# Church of God

TO: Rev. Earl R. Sexton  
FROM: Richard G. Hayman, Building Commissioner  
SUBJECT: Review of Church of God  
DATE: January 13, 1981

Re: *230 Glenwood*  
Review for compliance  
Church of Gof, Glenwood Ave.

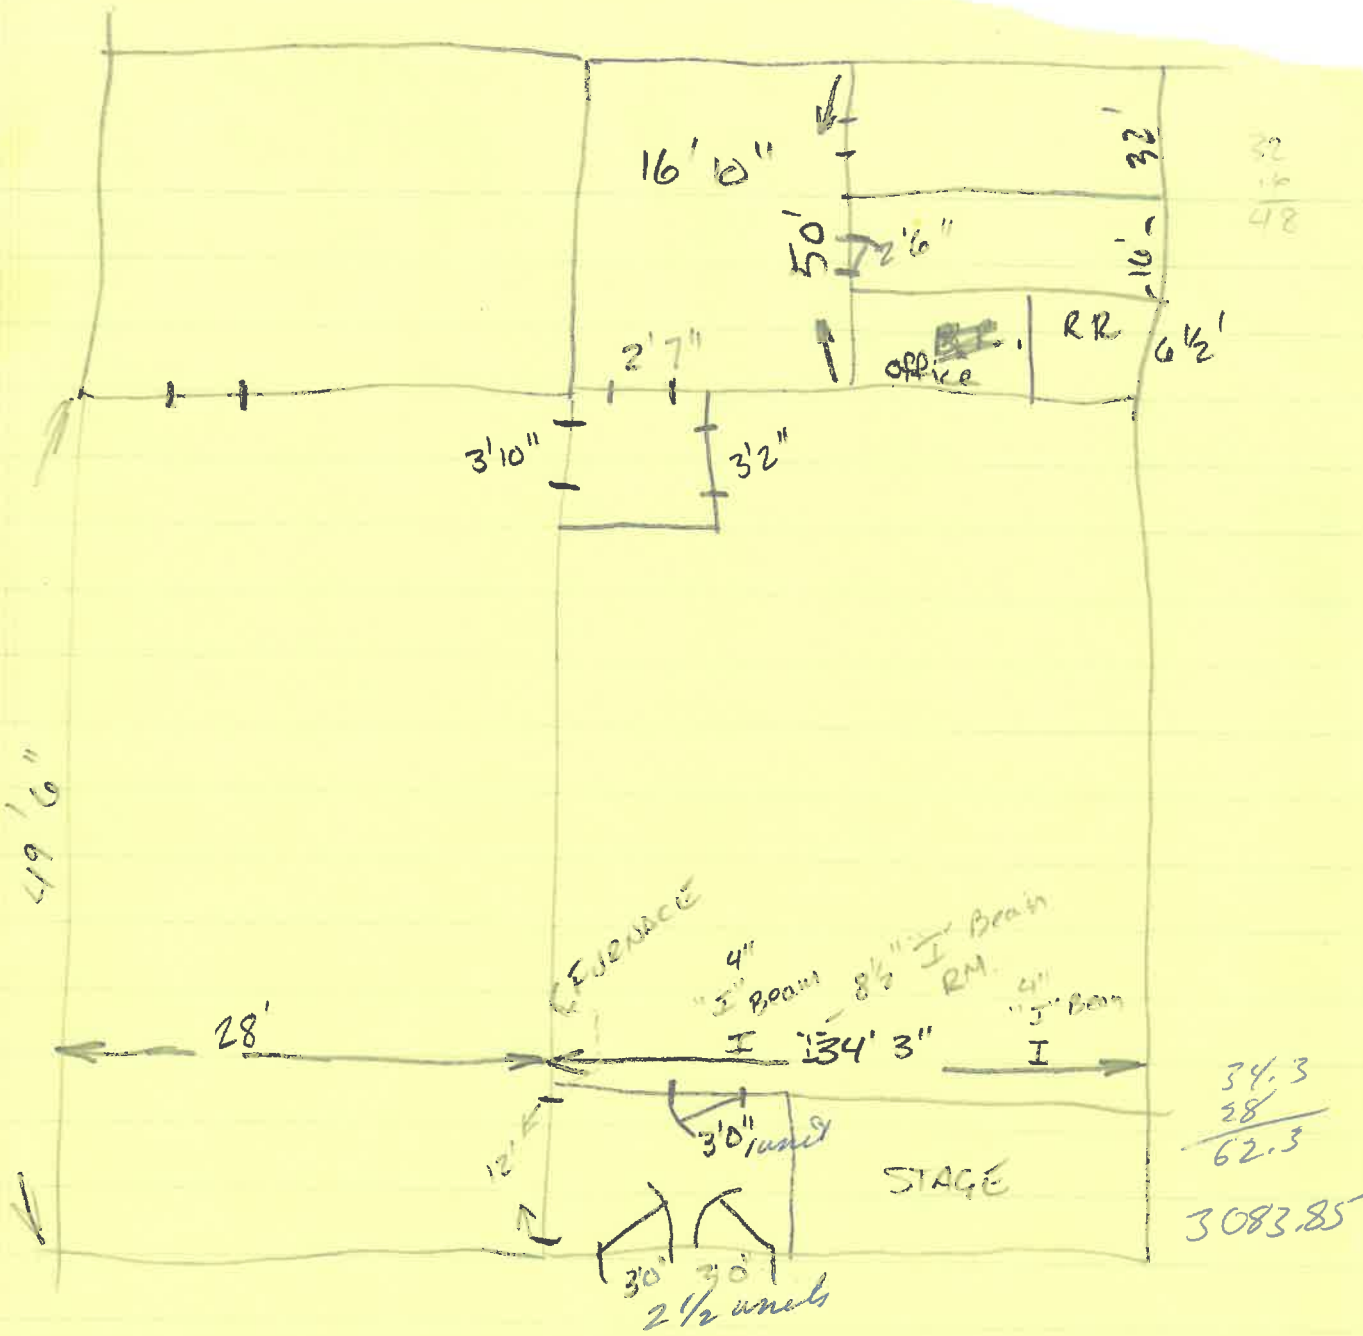
1. All exterior doors shall have panic type hardware.
2. Bathroom doors shall swing into the bathrooms.
3. Door leading from Room #4 to exit way #3 shall swing into the exit way.

4. All exterior doors shall swing to the exterior.
5. All exit doors shall have exit signs.
6. Partitions forming exit ways shall have one sheet of 5/8 X rated drywall applied both side of stud walls.

7. Exit way ceilings shall be 1 hr. fire rated or other permitted 1 hr. fire rated material.
8. Furnace room shall be made large enough to allow 6 inch clearance on the sides and back and 24 inch working space on the front.

9. Furnace room walls shall have one sheet of X rated drywall applied to the inside of the walls and ceiling.
10. All doors leading into exitways shall be solid core doors and a minimum of 1 3/8 inches thick.

11. All rooms other than exit ways shall have ~~Class III~~ interior finishes.
12. Structural stability of support posts supporting beam in front of platform. Engineer's or Architect review.

1. All wiring shall be in pipe.
2. Emergency circuit for exit lights.
3. Bathrooms shall have exhaust fans.

FURNACE INTAKE FROM FOYER
